**TOWN OF AMHERSTBURG
DRAINAGE BOARD
Wednesday, August 9, 2023
6:00 PM**

MINUTES

5.1 **Lakewood Drive Drain No. 3 & Pumping Scheme**

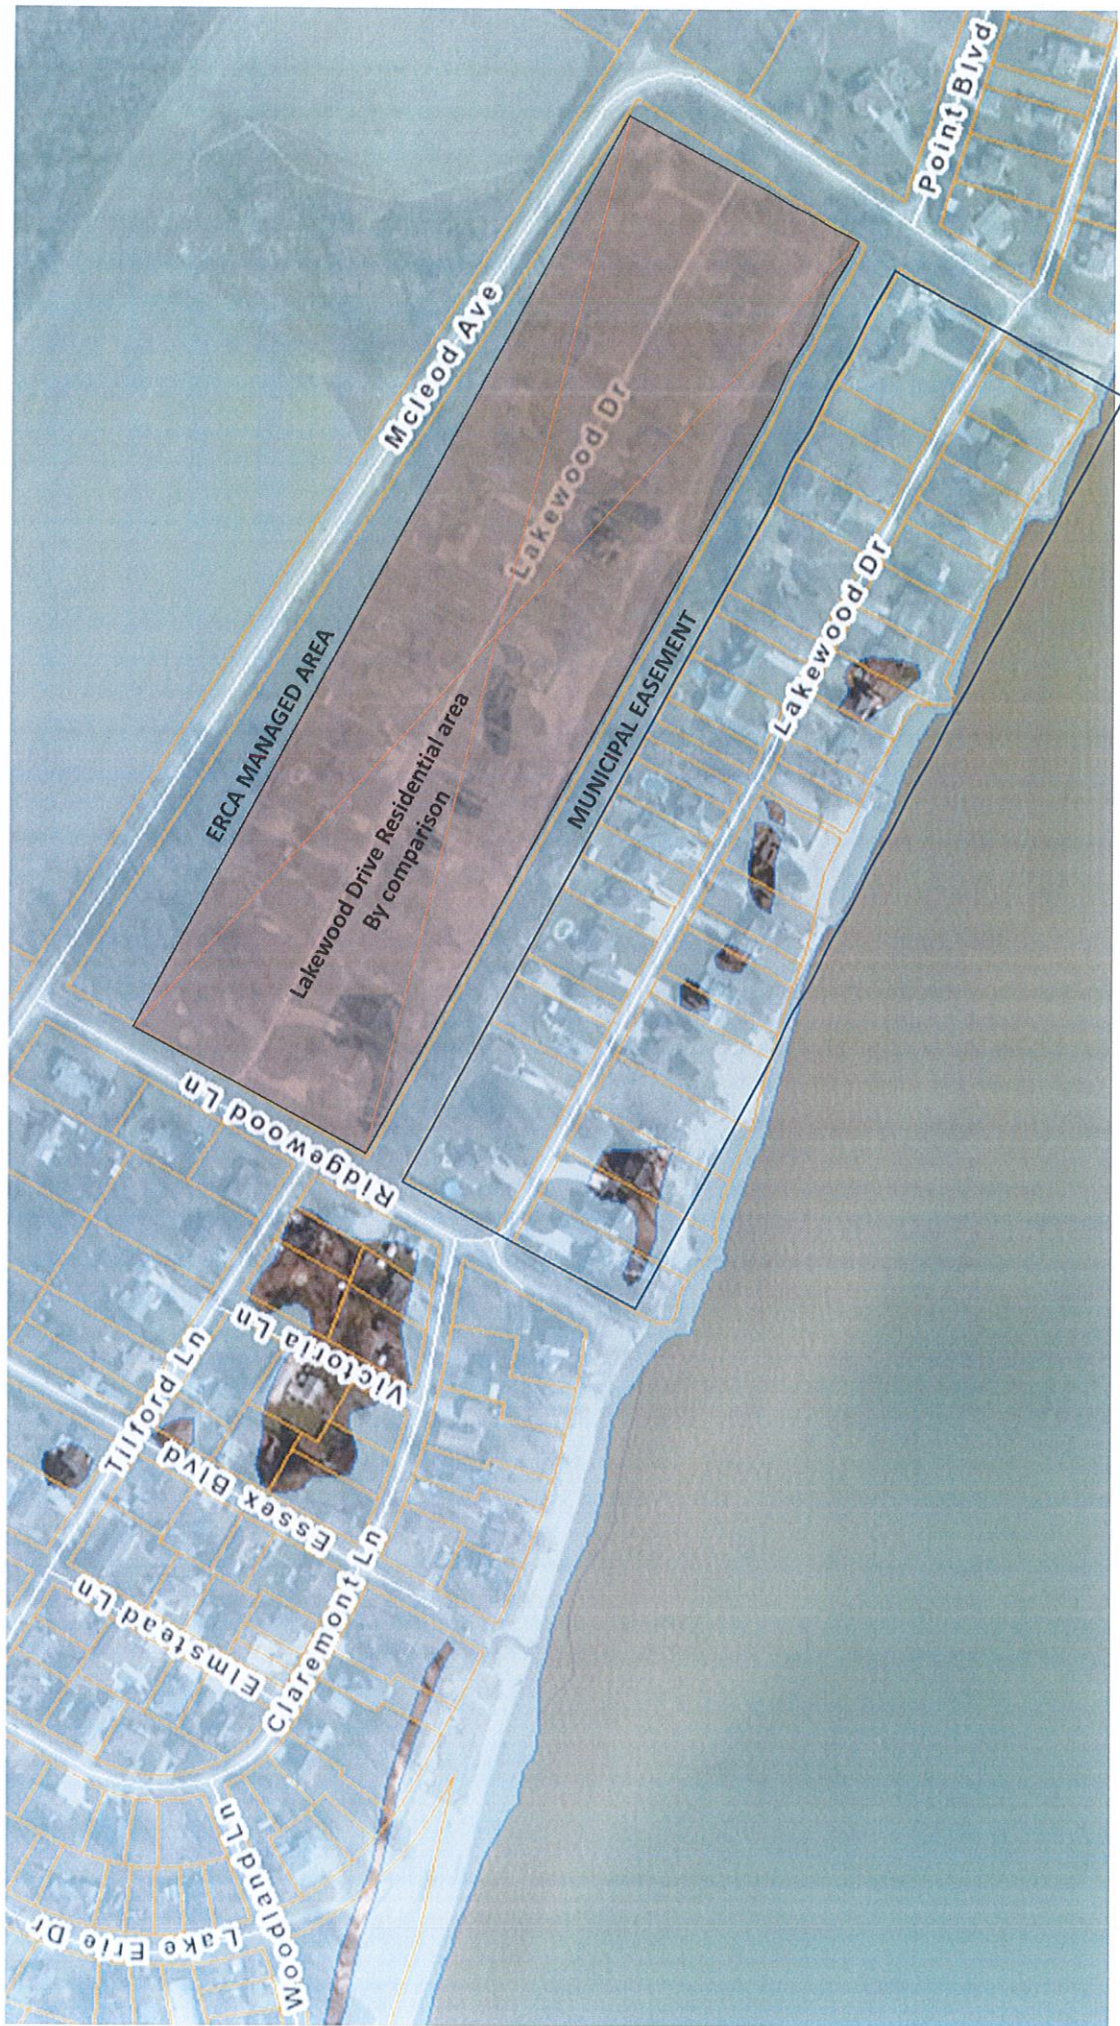
10. Reference page 19 of the report. "The Town plans to reconstruct McLeod Avenue but cannot justify the works while the drainage issues persist." A summary of the construction initiative and scope of works to be considered would be helpful to understand the future state conditions.

Attached is an image of the area. The shaded area over ERCA managed land represents the residential footprint of interest on Lakewood Drive.

PLAN, PROFILES and DETAILS
 OF THE
BAR POINT DRAINAGE SYSTEM
 IN THE
 TOWNSHIP OF MALDEN
 IN THE
 COUNTY OF ESSEX - ONTARIO
 SCALE PLAN 1" = 50'

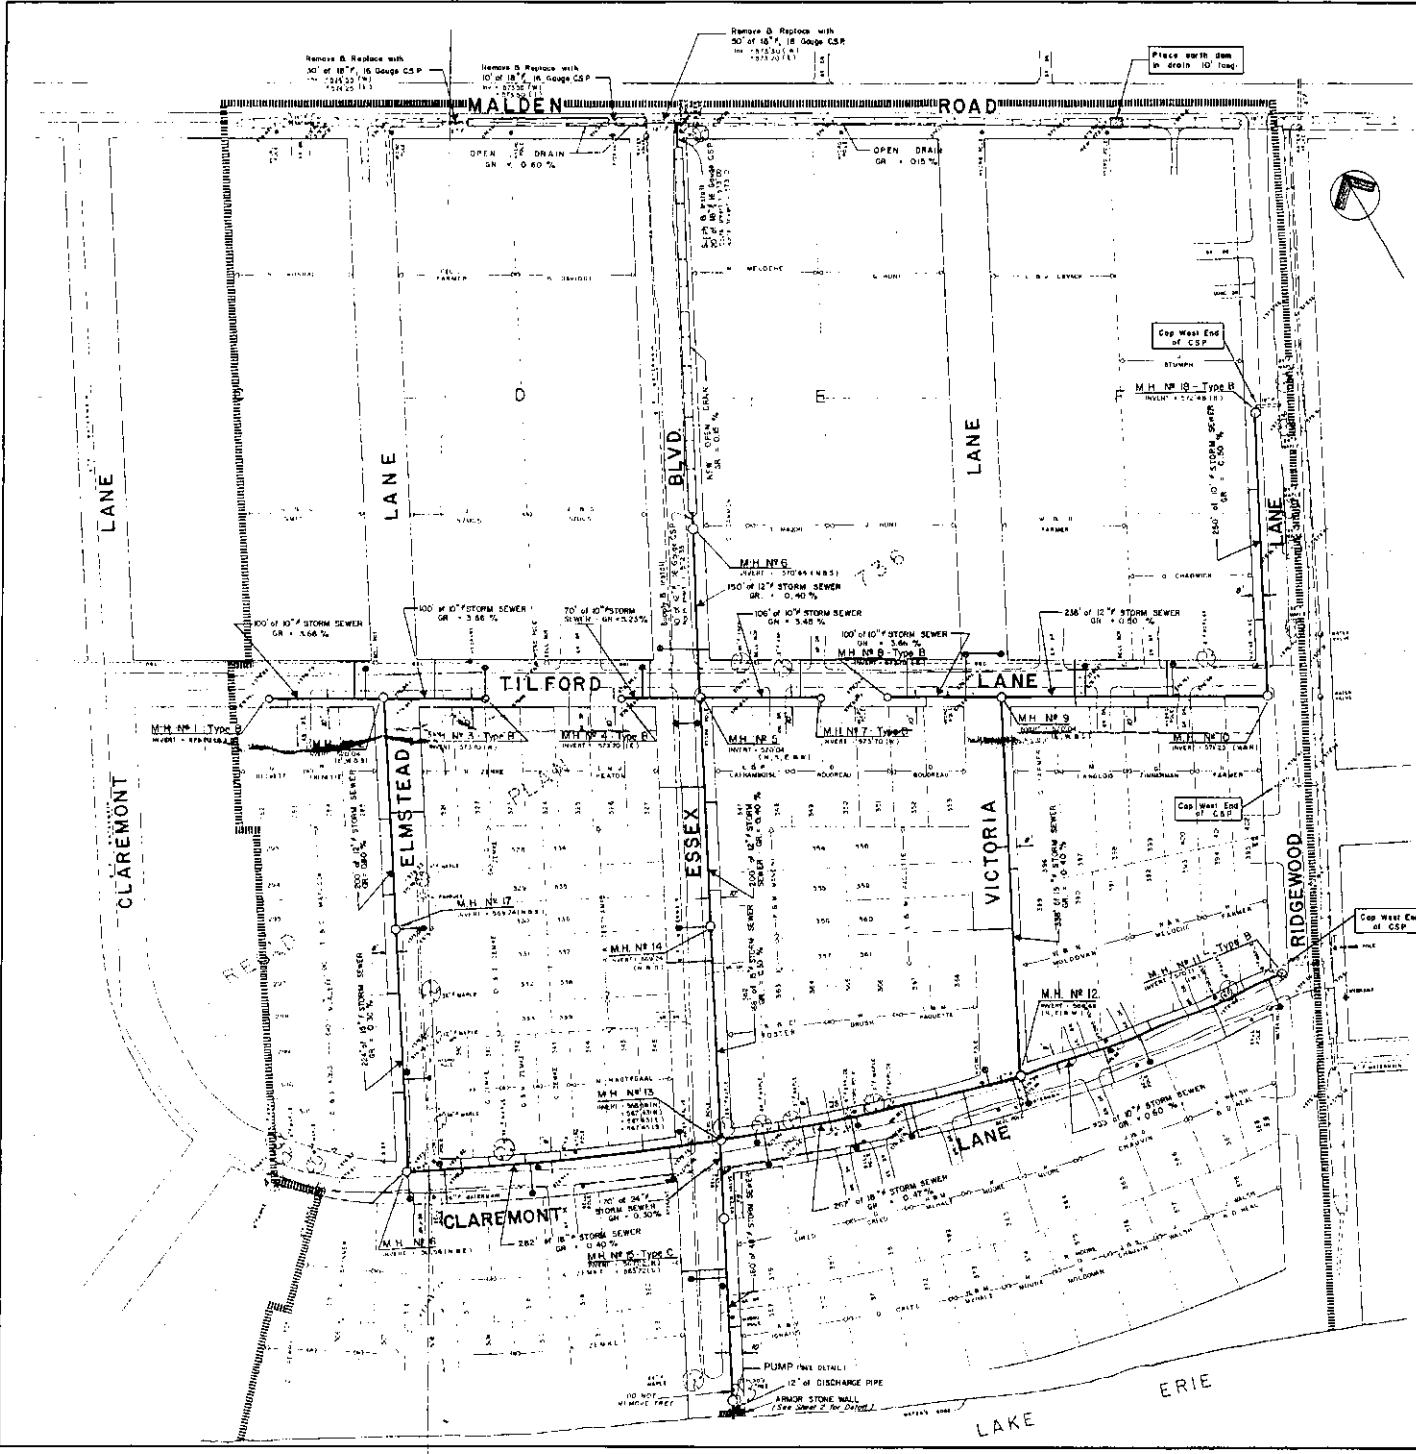
10. Reference page 19 of the report. "The Town plans to reconstruct McLeod Avenue but cannot justify the works while the drainage issues persist." A summary of the construction initiative and scope of works to be considered would be helpful to understand the future state conditions. **(The Town is the requesting body for this work. See opening statement of the report). Just like any other landowner, the Town has the right to apply for drainage works for its lands (Roads) to obtain a legal outlet.**

Attached is an image of the area. The shaded area over ERCA managed land represents the residential footprint of interest on Lakewood Drive.

1. Drainage history as summarized in the report sends a clear message regarding deficient drainage dating back before 1975. It is understood that existing homesteads prior to environmental management of the area would ultimately require corrective actions. Was there an actionable drainage plan going forward to support ongoing building permits and development with unsuspecting home owners. **The 1975 request and report was never adopted or built. The pump station bylaw dates back to 1981 where the creation of the drain was for residential lands bound by Claremont Lane. In this bylaw, there exists a watershed boundary for the serviced area. The drainage plan from the 1981 report is attached for reference. Your land is not within the boundary.**
